# Memorandum

**Re:** Petitions PLNHLC2014-000730 & PLNHLC2014-00628  
New Single-Family Home at approximately 757 N. Wall Street

### New Single Family Dwelling New Construction PLNHLC2014-00730 and PLNHLC2014-00628 757 North Wall Street

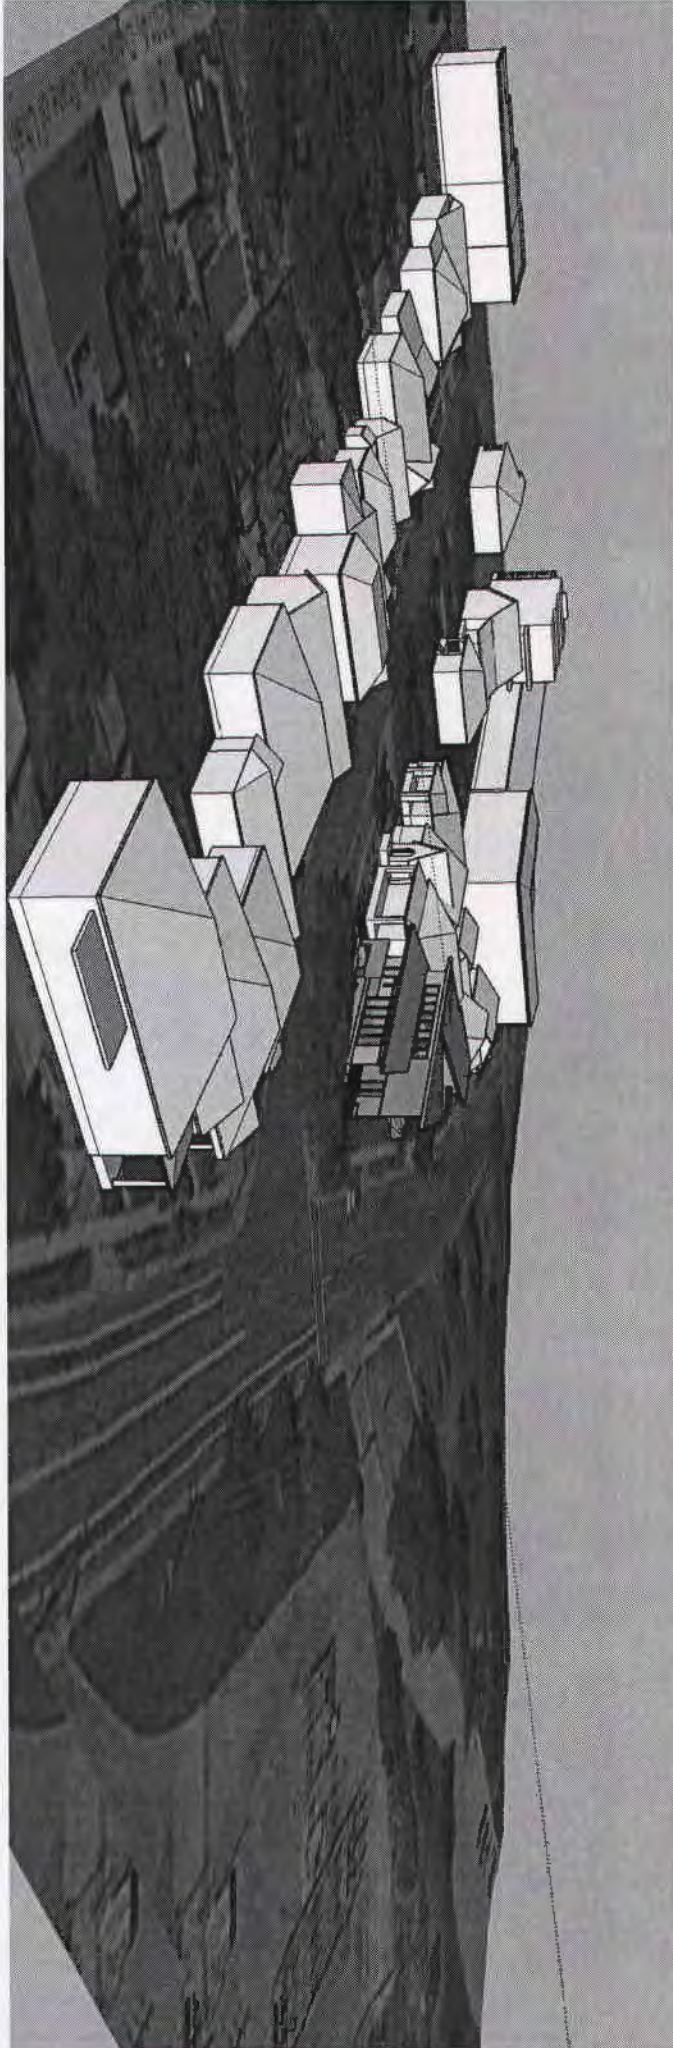
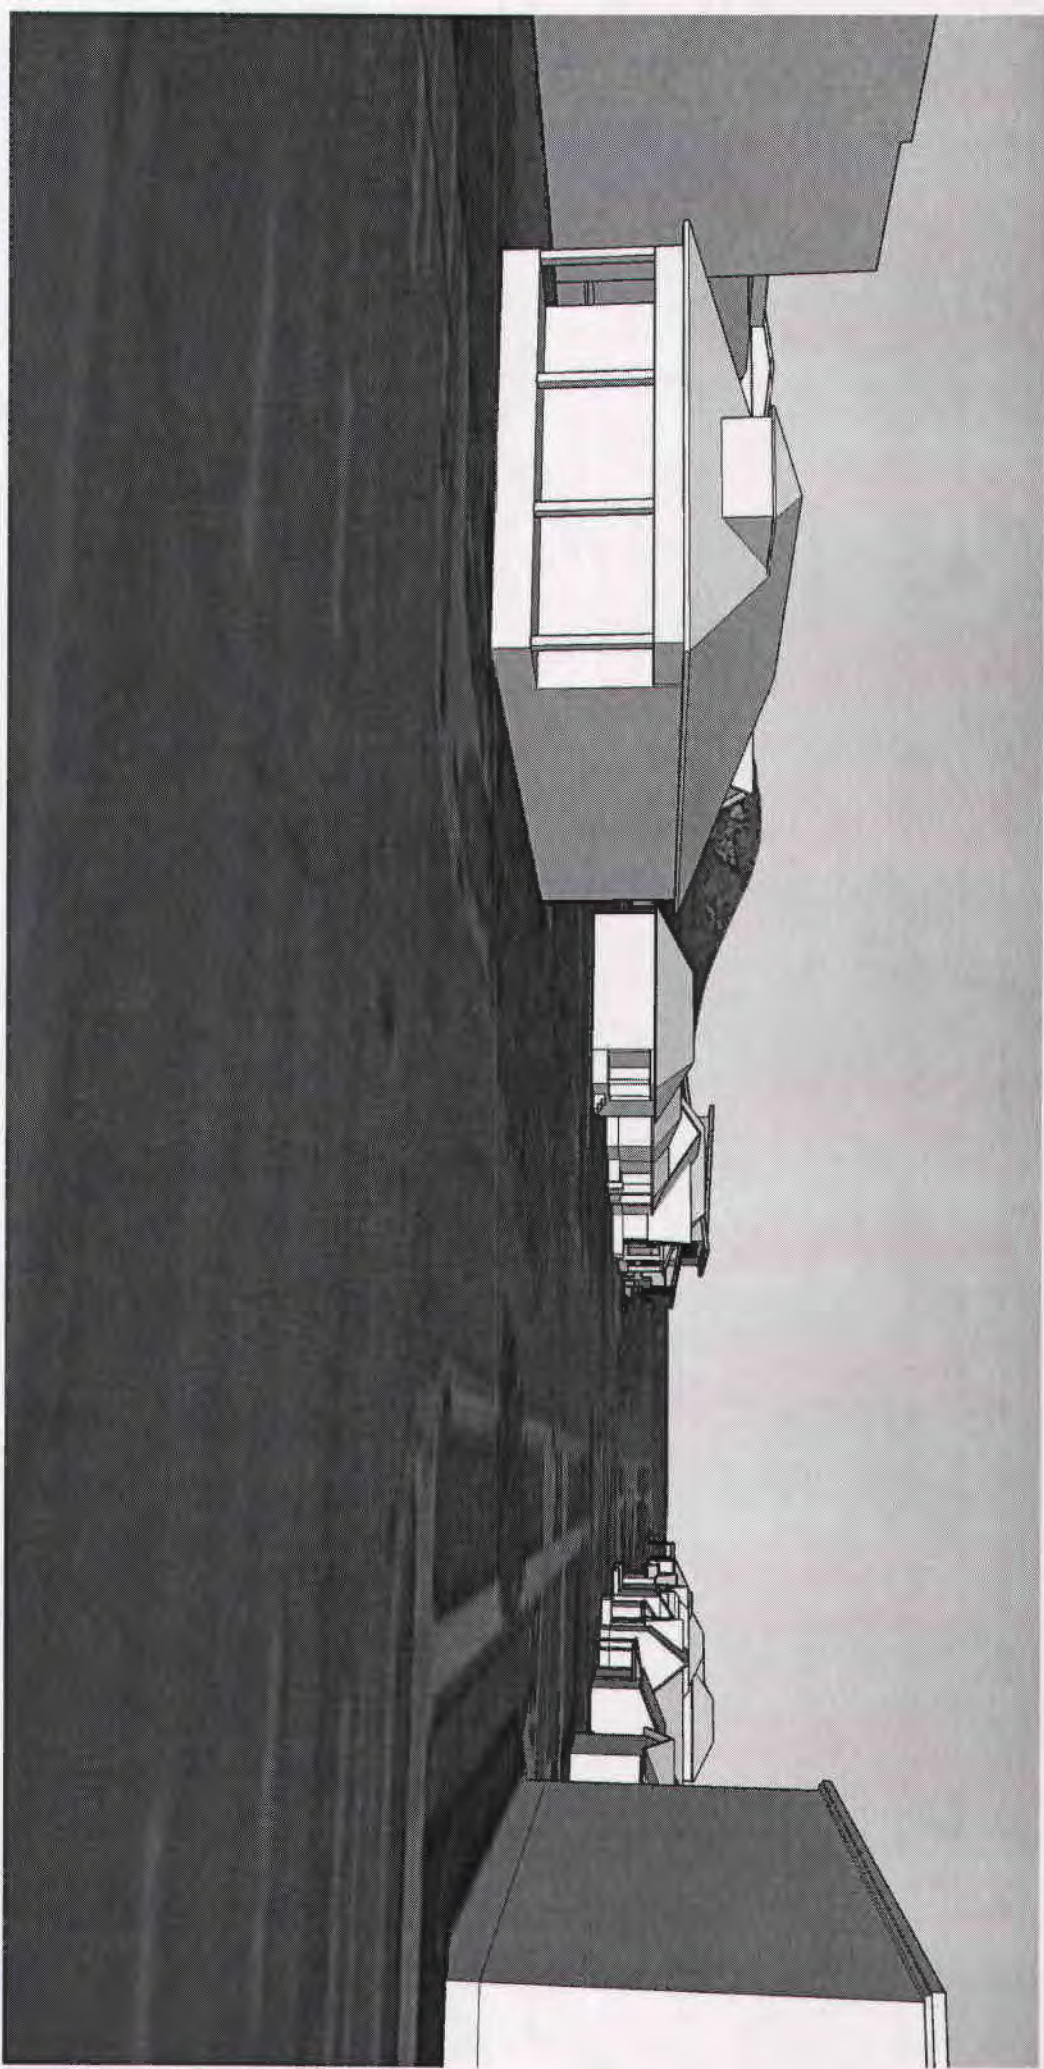
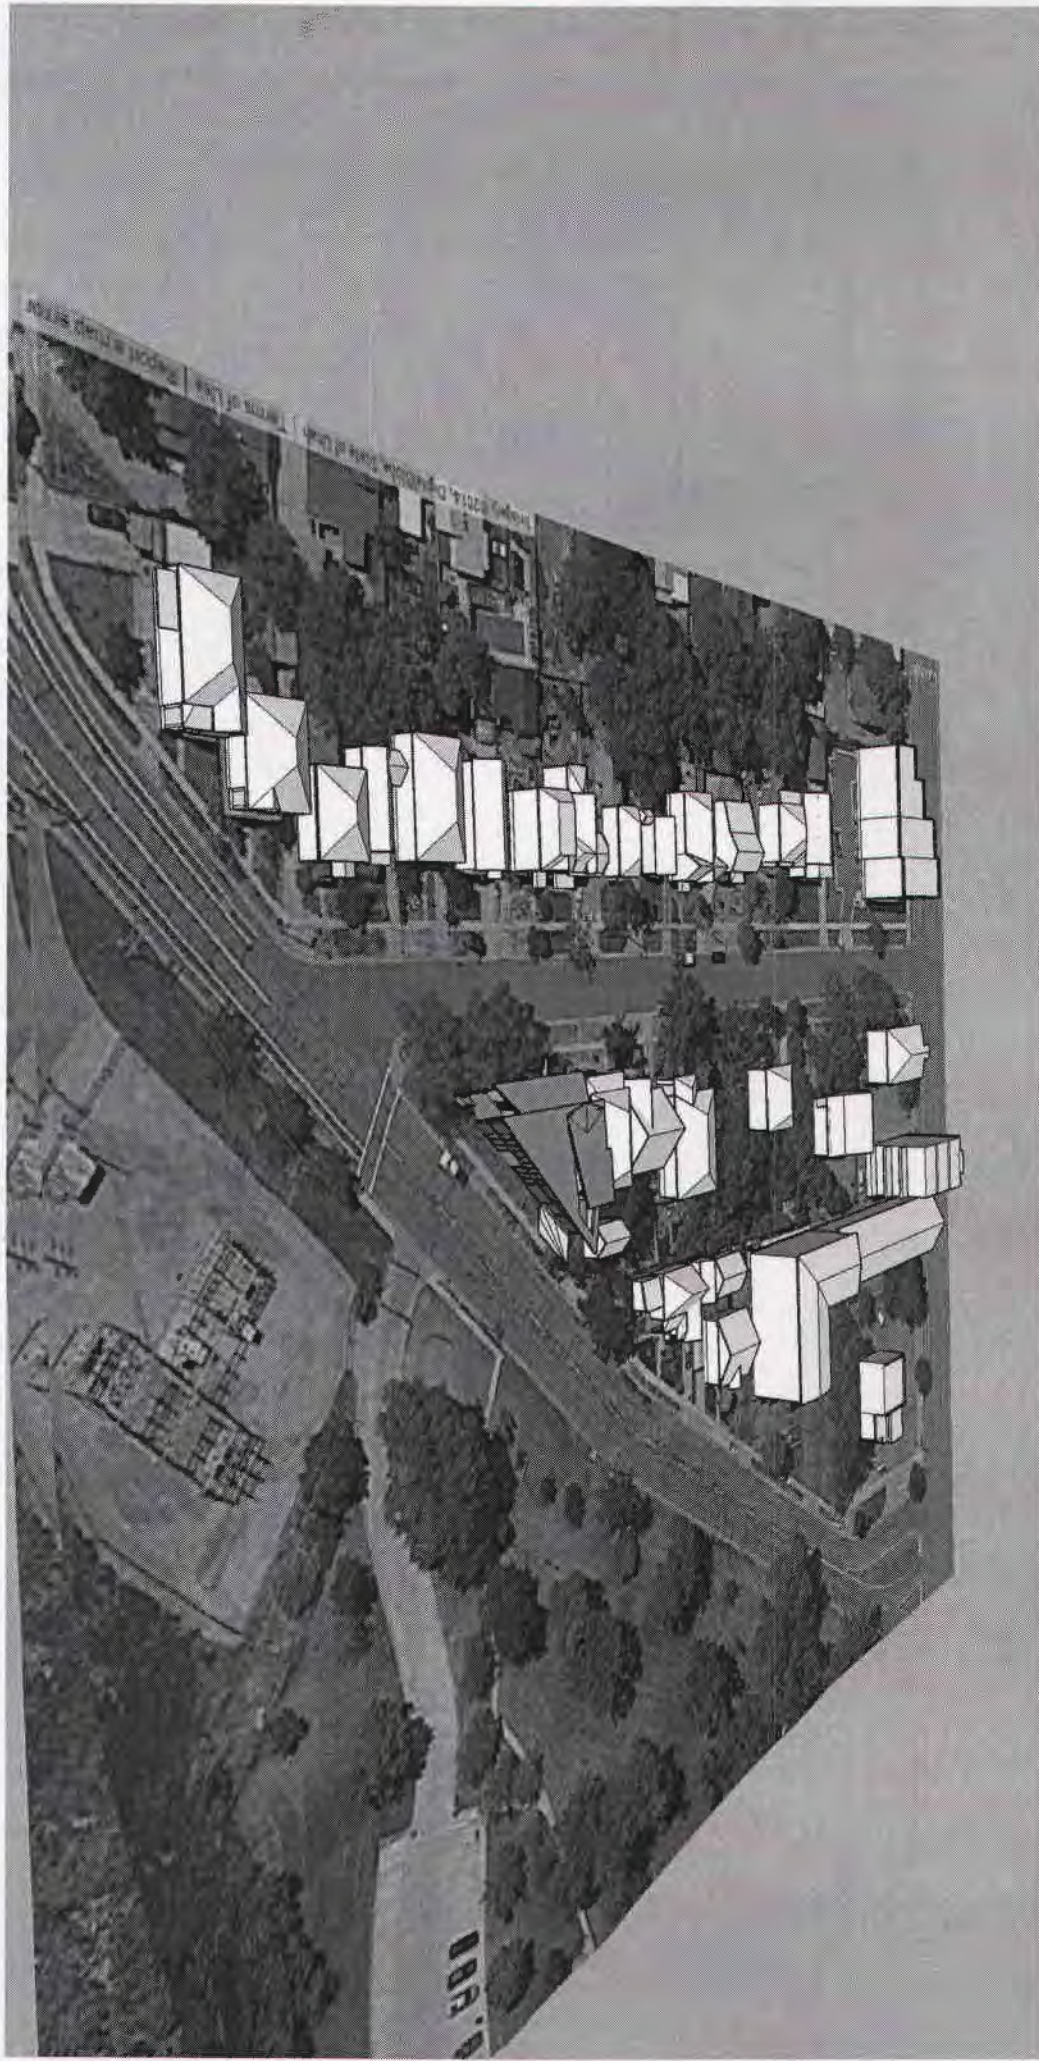
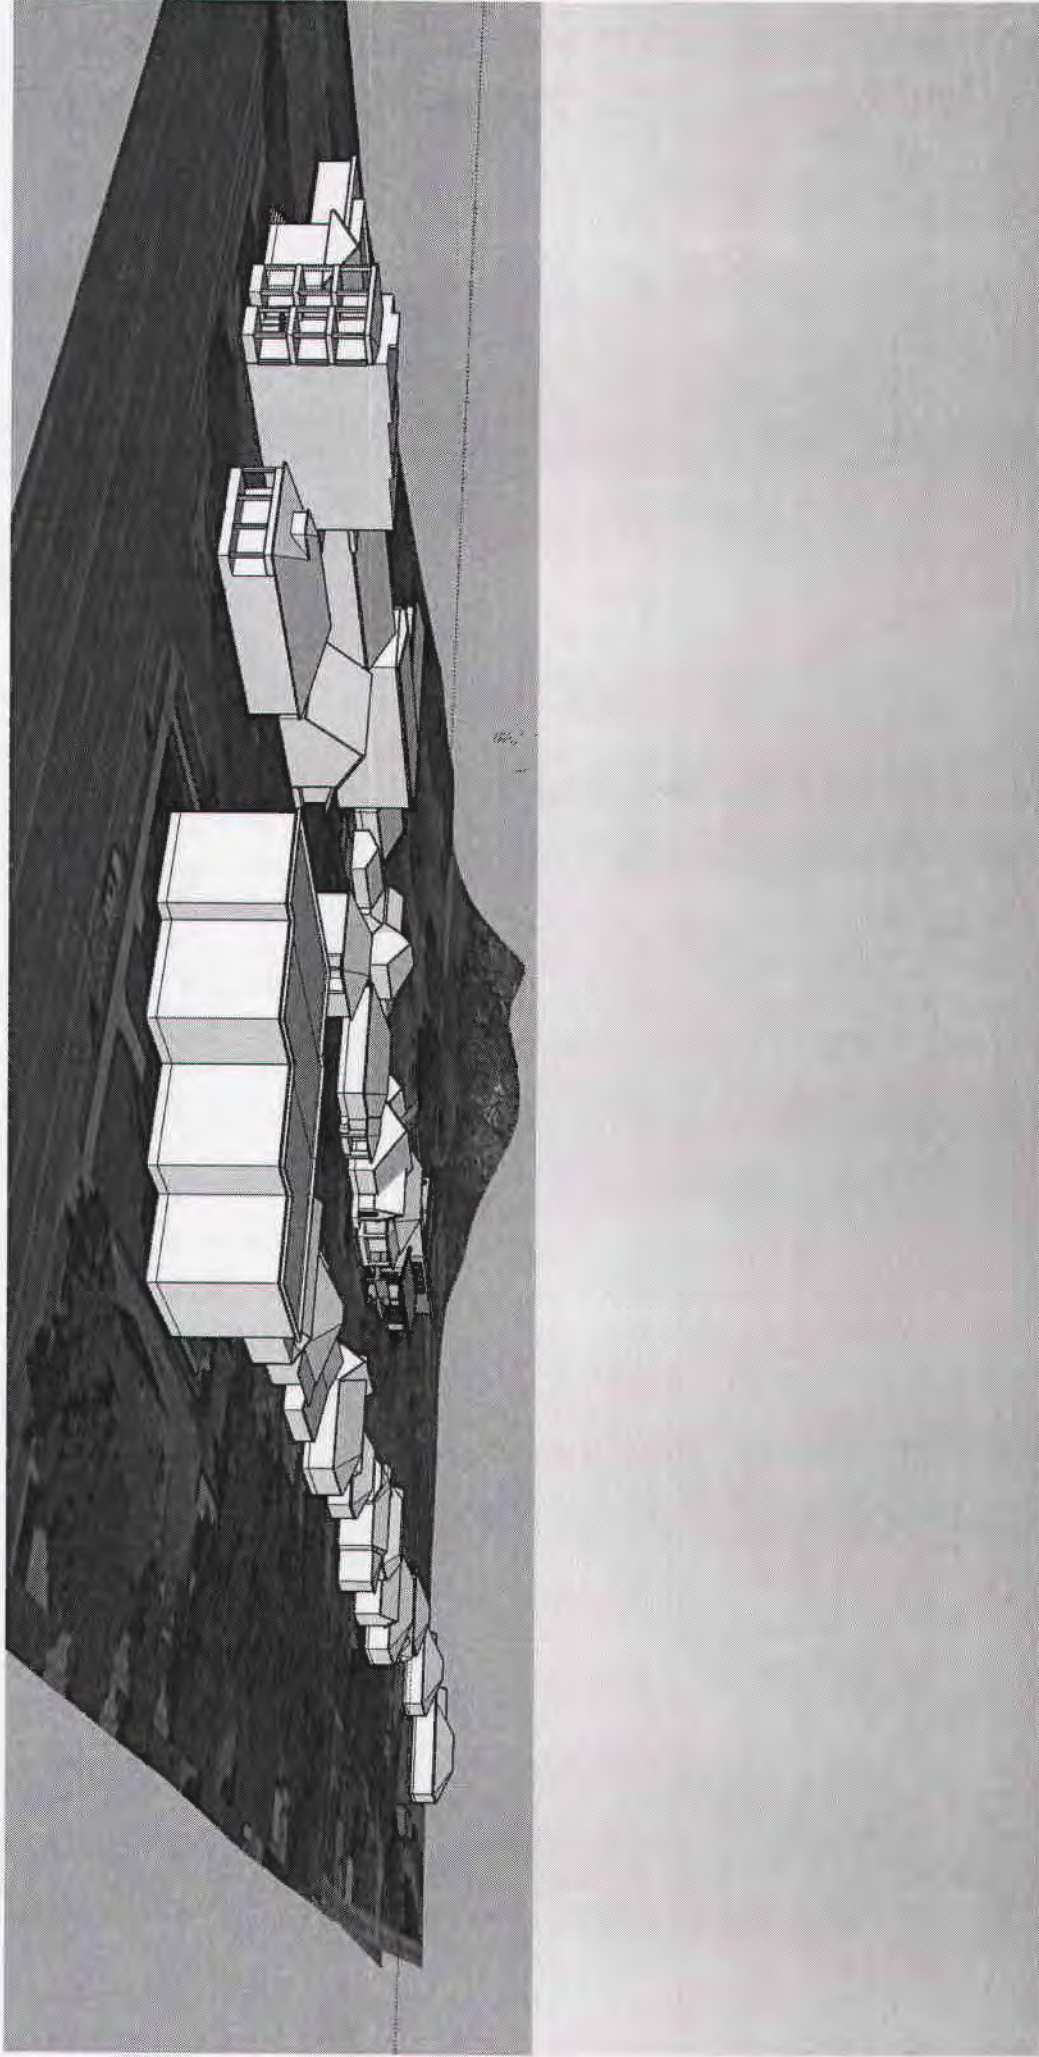
1. The proposed residence is out of scale with the neighborhood; it's too large.

2. The proposed residence is in excess of the maximum lot coverage.

3. The proposed residence should embrace both Wall Street AND Reed Avenue.

4. Shorten the total length of the facade along Wall Street.

5. The proposed residence is too tall.

Applicant response - Due to the allowance of tandem parking, we were able to reduce the footprint of the home from approximately 2,300 square feet to 1,438 square feet and still provide the required 2-car parking: the garage is approximately 327 square feet for a total footprint of 1,765 square feet, a 23% reduction.

Applicant response - The new design represents a 10% reduction in lot coverage. If we calculate the area of the lot sidewalk to sidewalk, the lot coverage drops from 45% to under the 40% maximum requirement at 35% lot coverage. However, due to the unusual property lines, we are still requesting an exception for lot coverage, which is now 53% calculated by actual lot size (down from 63%).

Applicant response - We have embraced Reed Avenue by accentuating the sidewalk approach to the front door and have expanded the courtyard at the southwest corner of the home along the street. The enlarged courtyard becomes more welcoming and inviting. In addition, we believe that the roof-line on Reed Avenue successfully embraces the porch elements found throughout the neighborhood.

Applicant response - By eliminating the attached 2-car garage, we were able to shorten the overall length of the home on Wall Street by over 20 feet. In addition, the enclosed garage is set back from the sidewalk by 25-30 feet, which greatly softens the facade along Wall Street. Our re-design initially proposed a detached garage. However, the garage has been attached to the home, allowing for the required 4' side yard set-back. The garage/west wall is a full 10' from the neighboring home.

Applicant response - Due to the new garage design, we have eliminated the need for a height exception, as the home no longer extends into the southwest corner of the lot.
